802.3dj D1.3 Comment Resolution Optical Track

Tom Issenhuth (Huawei)
Matt Brown (Alphawave Semi), 802.3dj Chief Editor

- This slide package was assembled by the 802.3dj editorial team to provide background and detailed resolutions to aid in comment resolution.
- Specifically, these slides are for the various optical track comments.

Figure 121-4—TDECQ conformance test block diagram

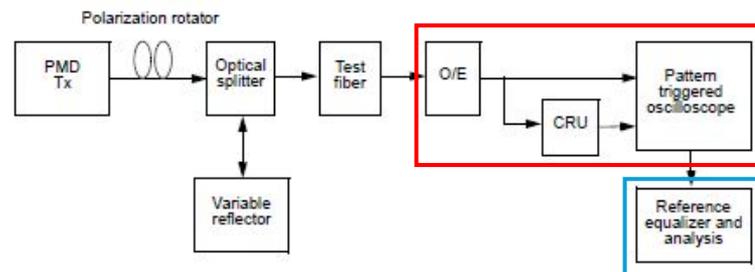
- While the wording is a bit awkward, it's clear that the **reference receiver** is distinct from the **reference equalizer**, and does not contain it.
- This is reinforced in 121.8.5.1, Figure 121-4, which shows the **reference equalizer** separate from the O/E and calibrated oscilloscope that form the **reference receiver**.
- It's unfortunate that the text in 121.8.5.1 doesn't repeat the term, **reference receiver**, which is a source of some of the current confusion.
- Another source of confusion comes from the fact that the **reference equalizer** is typically implemented in the oscilloscope but is not defined as part of the **reference receiver**.
